# Service Bulletin

Bulletin No.: 17-NA-333

**Subject: Power Tilt and Telescope Switch Pushes into Steering Column**

4284151

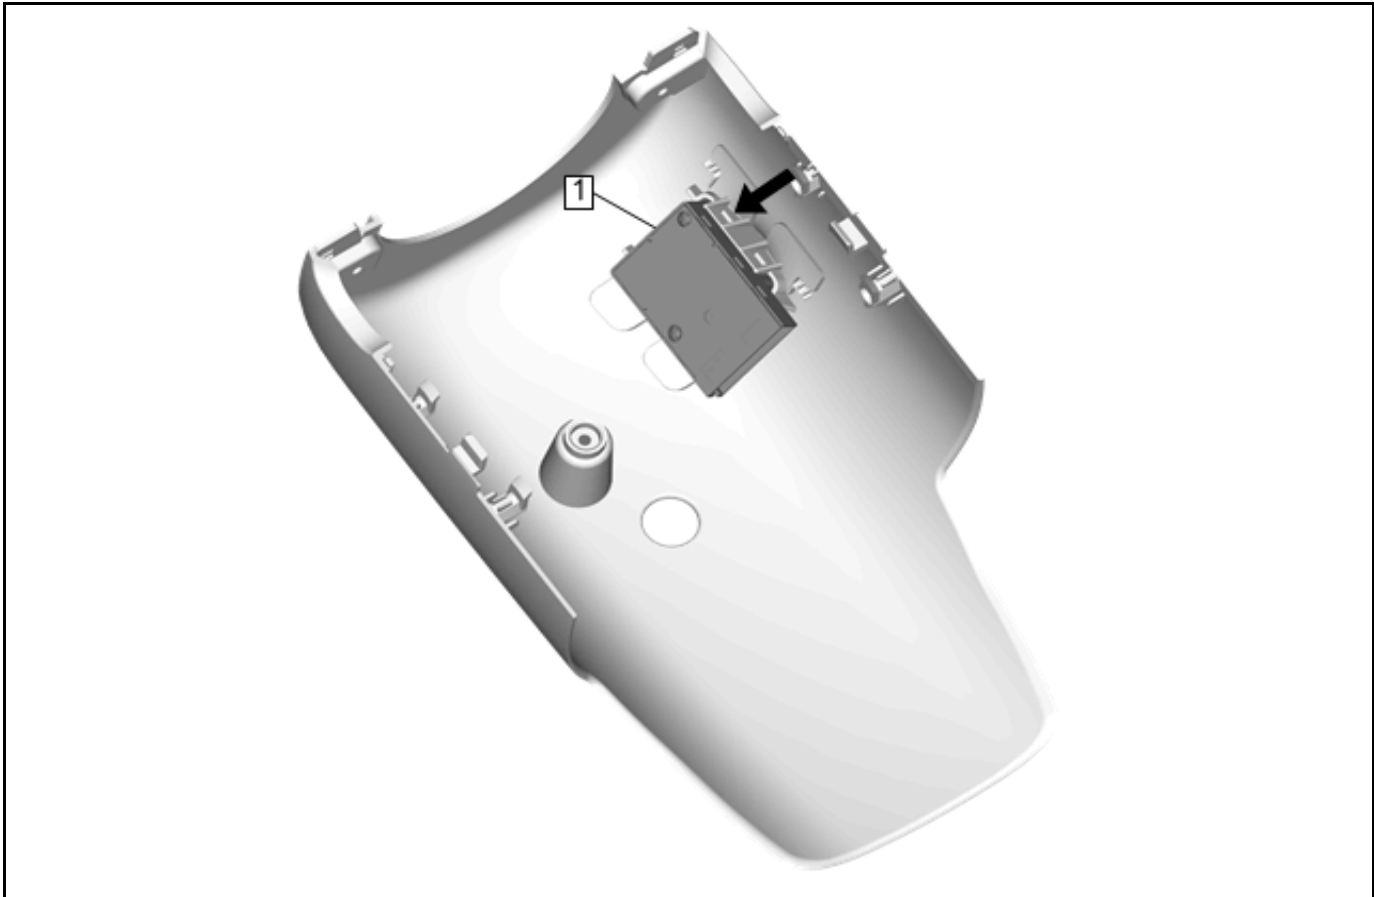
<b>Involved Region or Country</b>	North America, South America, Middle East, North Africa and Russia.
<b>Condition</b>	Some customers may comment that the Power Tilt and Telescope Column switch can be or has pushed into the lower column cover.
<b>Cause</b>	This may be due to the lower steering column cover switch retention features do not apply enough force on the side of the switch to retain the switch if pressed hard or bumped by a knee.
<b>Correction</b>	Apply butyl tape around sides of switch pocket to hold the retention clips against the switch using the procedure outlined below.

3. Apply butyl tape around sides of switch pocket to hold the retention clips against the switch.
